Access Compliance Report Public Rights-of-Way (Curb Ramps)

Main Street: COVENTRY_PL Cross Street: HYDE_PARK_DR Location: SE

ADA ID: RPRK211013105322 Ramp Type: Type 4 - Parallel Initial Pass/Fail: Fail Overall Compliance: No Severity Score: 16

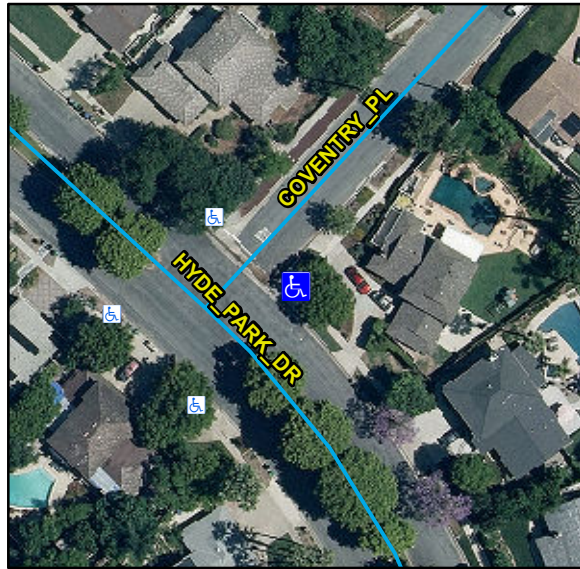
R304.3.2, R304.5.3, STD 1115

Remove & Replace Curb Ramp With Two New Directional Ramps or Equivalent.
